REFERENCE	BT_2013_FR1.6_2_UK
DATE	May 16th, 2013
SUBJECT	FR1.6 systems update 1
PART	Transponder bracket, steering column, fuel tank hose, sidepod chimneys

1. Transponder location

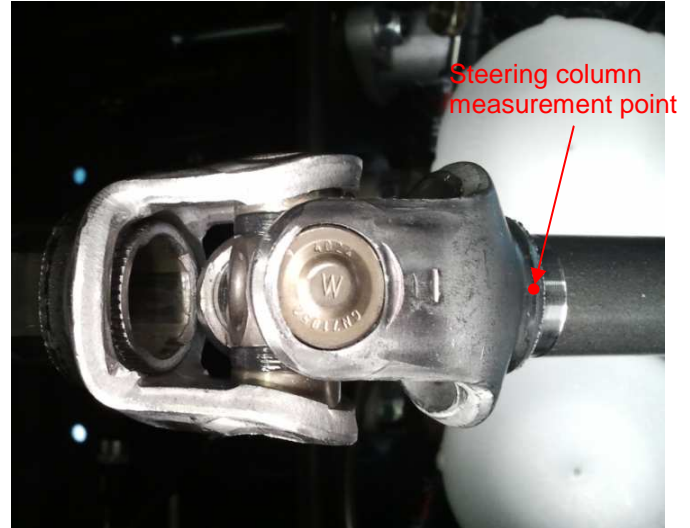
The transponder must be fitted on the left hand side of the gearbox using a specific support plate designed by Signatech. The transponder has to be fitted to the gearbox as shown below:

Transponder bracket: ref. G04-20A017V1

2. Steering column universal joint

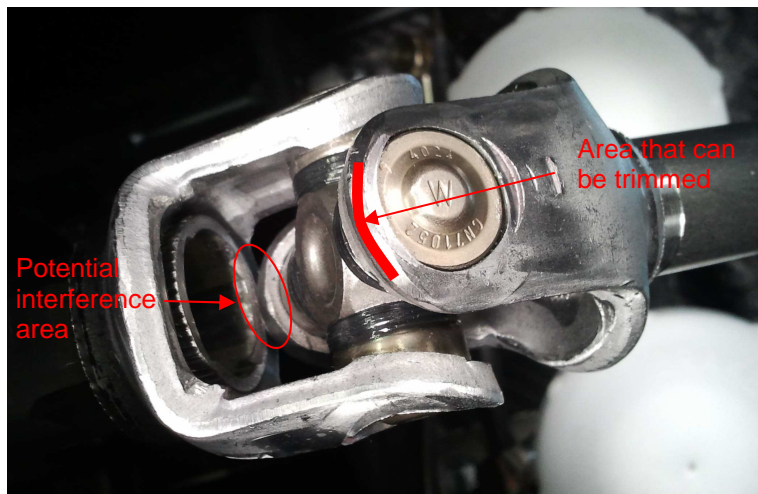
To avoid any interference in the steering column universal joint, the distance between the tub top and the back of the steering column universal joint must not be lower than 45mm as defined below:

It is allowed to trim the edge of the universal joint in case of remaining interferences.

3. Fuel T connector

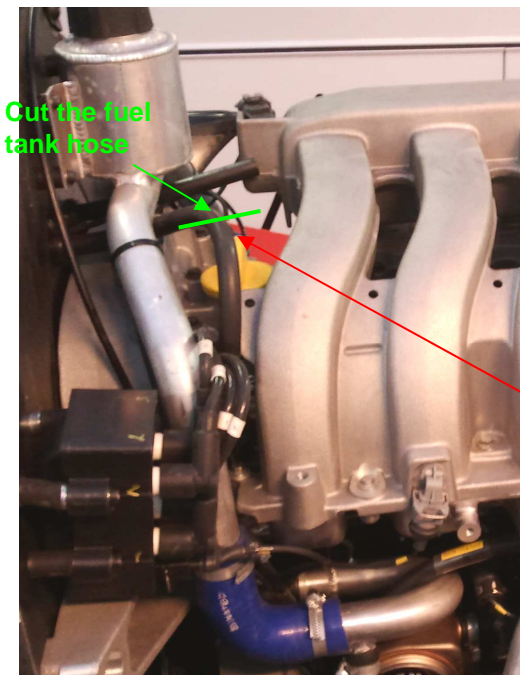
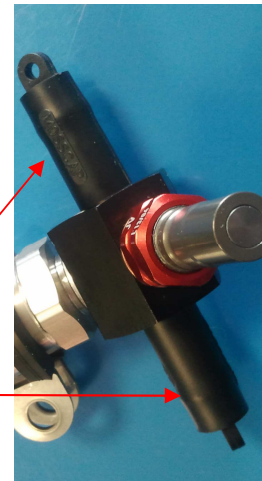
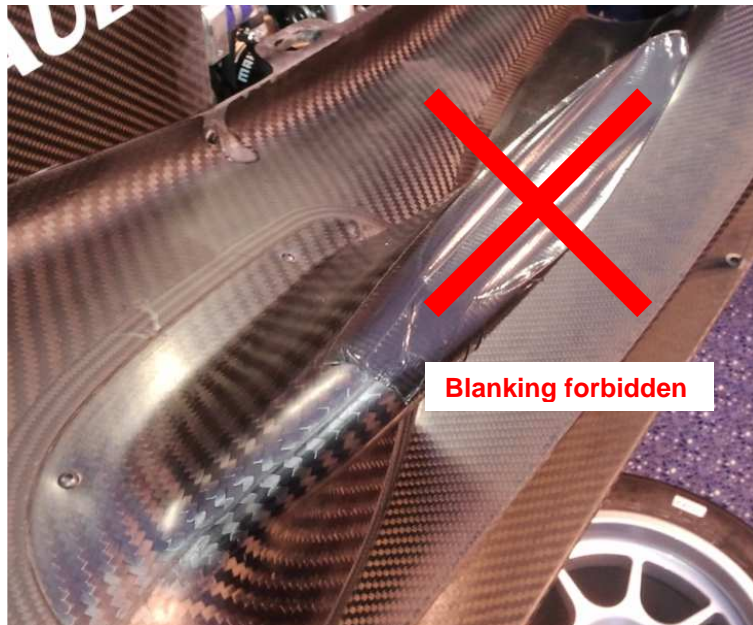
To ease the draining of the fuel tank and to avoid removing every time the genuine fuel rail connector, a fuel T-connector equipped with a quick release connector and a fuel pressure sensor must be fitted on the fuel hose as follows:

Insert the fuel T-connector by plugging the cut fuel hoses on both side of the fuel T-connector

The engine loom already includes the fuel pressure sensor connector, hence you can easily plug this new sensor.

- Fuel T connector kit ref. G04-01A017V1
- Fuel tank draining hose kit ref. G04-01A018V1
